Three Mile Island Unit 1
Route 441 South, P.O. Box 480
Middletown, PA 17057
Telephone 717-948-8000

April 28, 2017
TMI-17-029

SUBJECT: COMBINED 2016 ANNUAL RADIOACTIVE EFFLUENT RELEASE REPORT

**ODCM Change for TMI
Offsite Dose Calculation Manual, Revision 4
CY-TM-170-300**

**MAP 8.2
THREE MILE ISLAND NUCLEAR STATION
LOCATIONS OF RADIOLOGICAL ENVIRONMENTAL MONITORING PROGRAM
STATIONS WITHIN 5 MILES OF THE SITE**

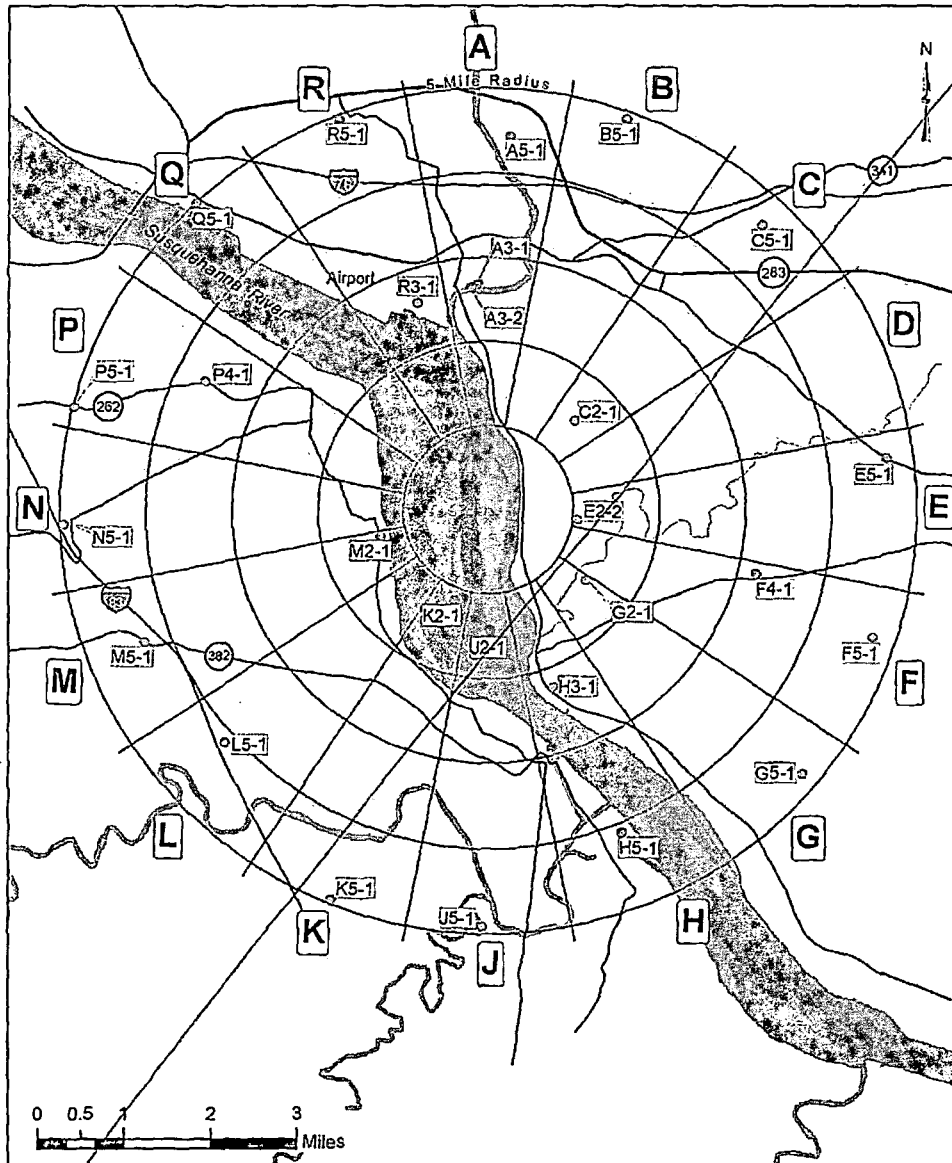
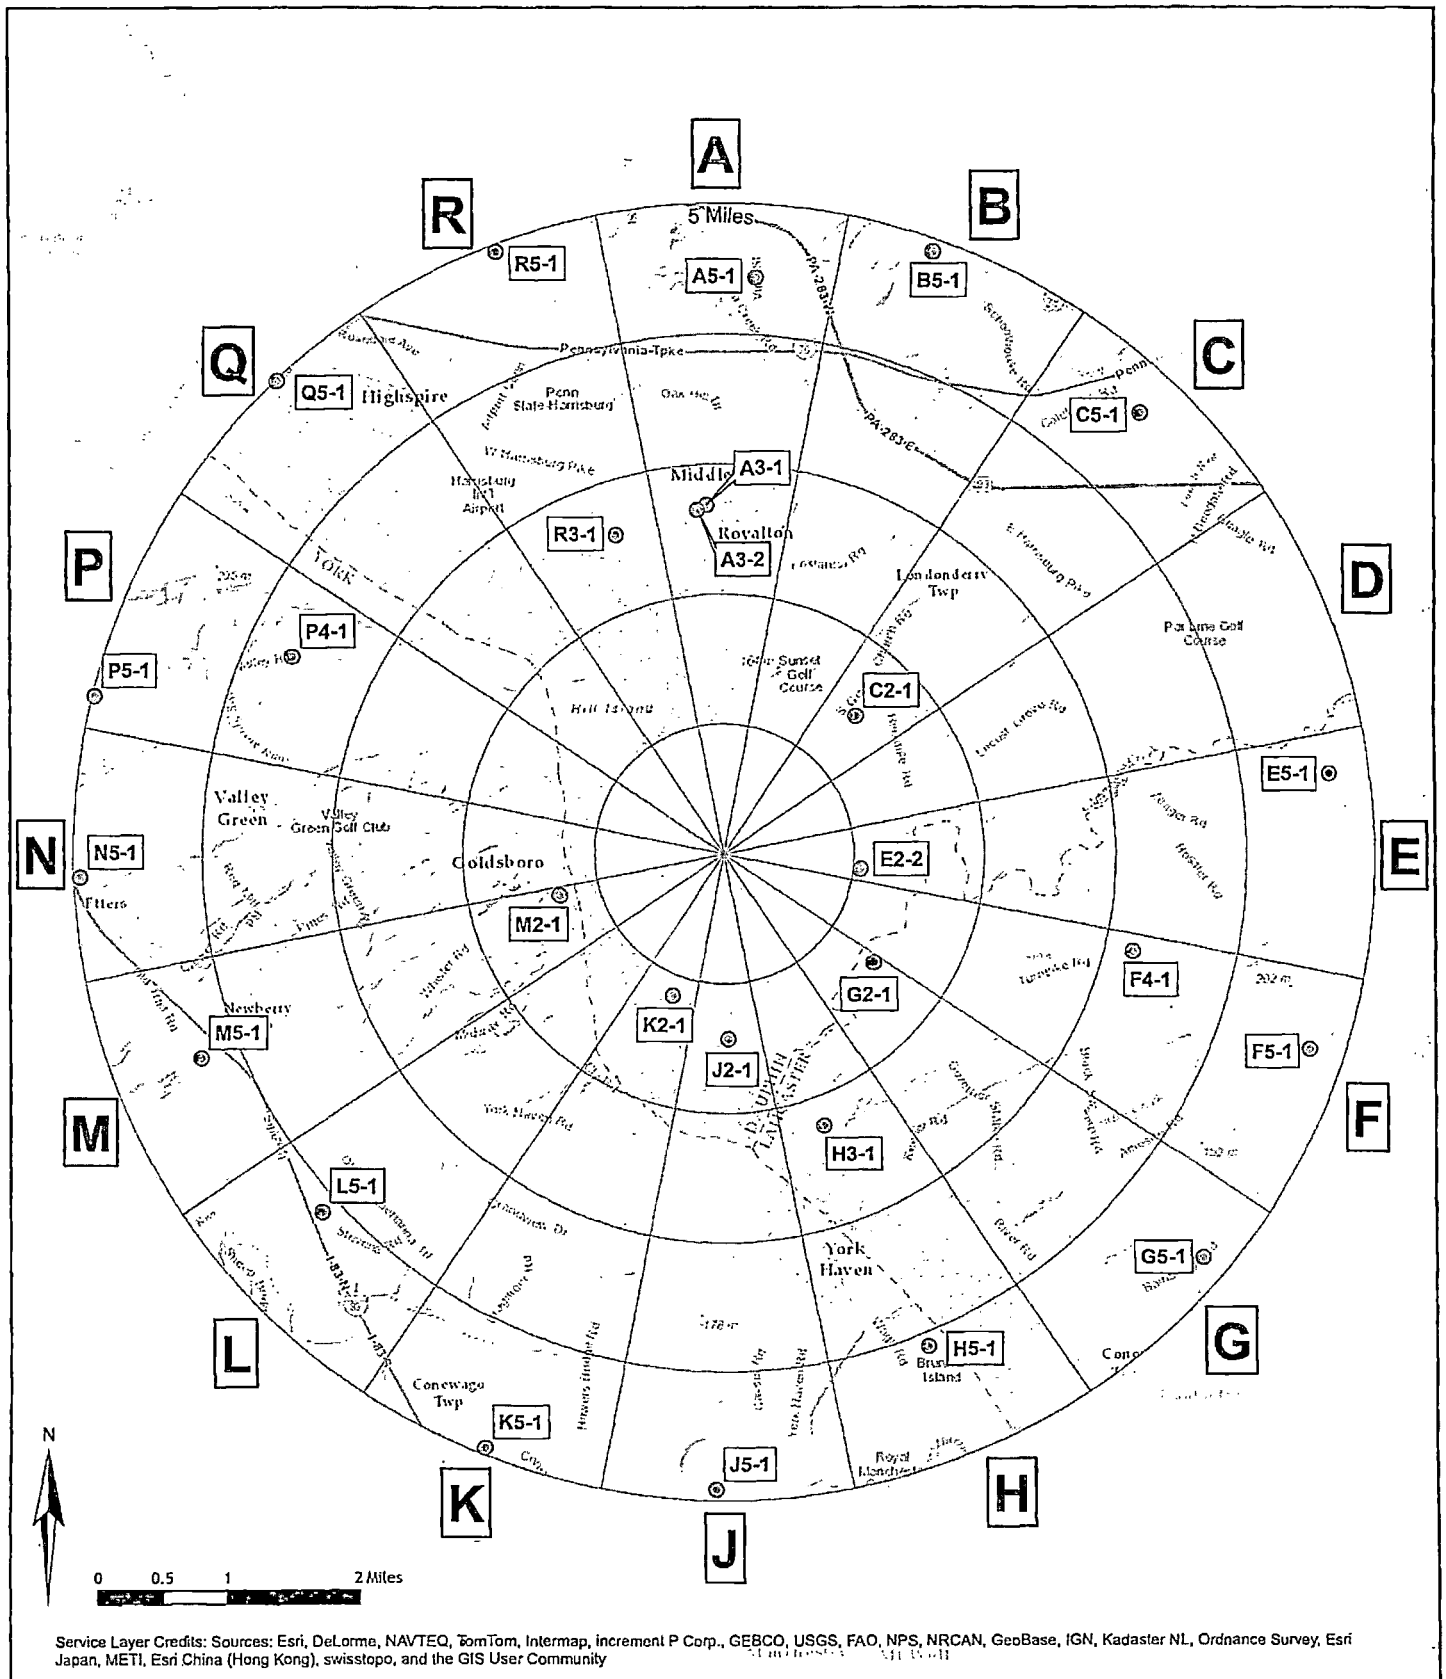
*Replace with
attached
(if available)*

MAP 8.3
THREE MILE ISLAND NUCLEAR STATION
LOCATIONS OF RADIOLOGICAL ENVIRONMENTAL MONITORING PROGRAM
STATIONS GREATER THAN 5 MILES FROM THE SITE

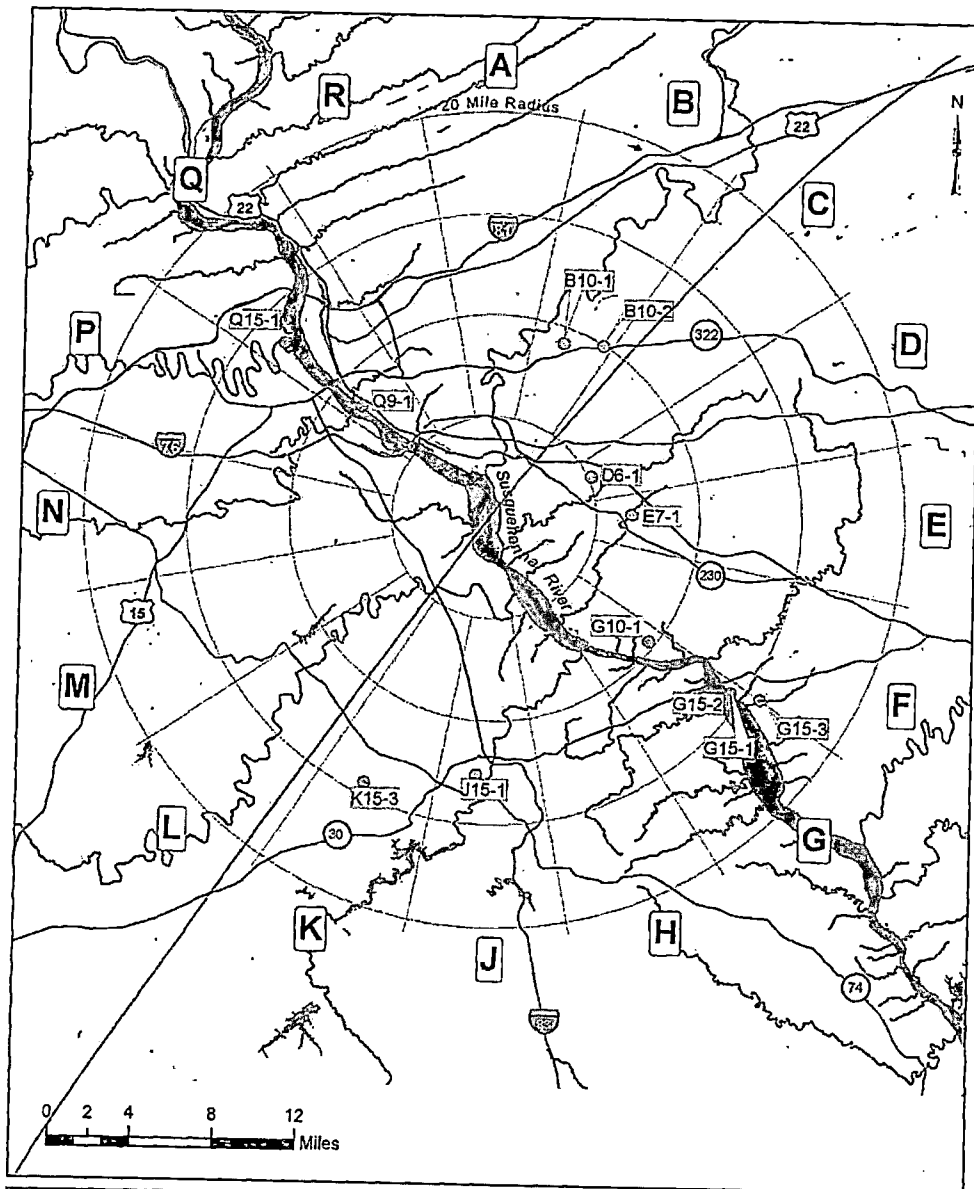
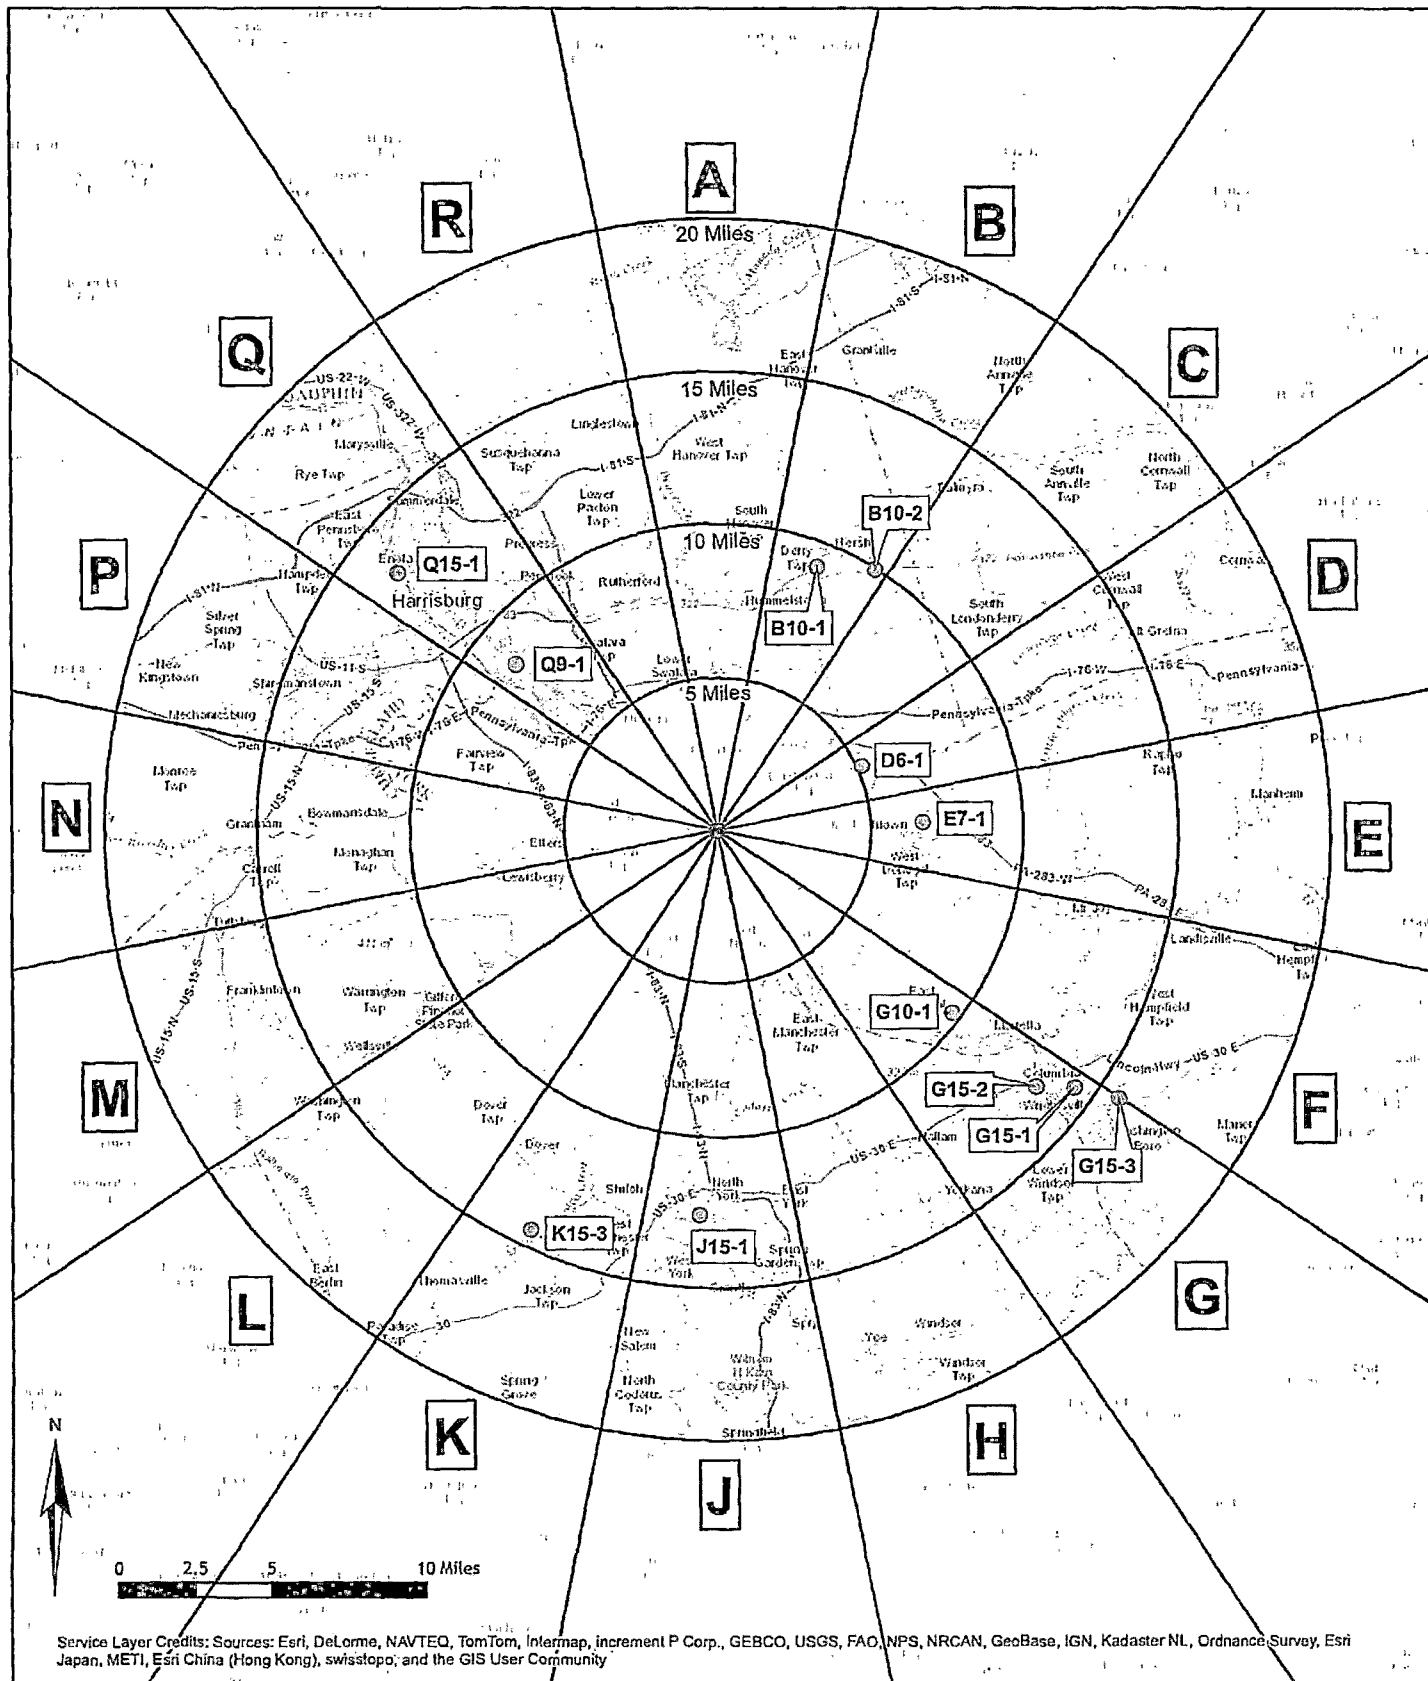
*Replace with
attached
(site available)*
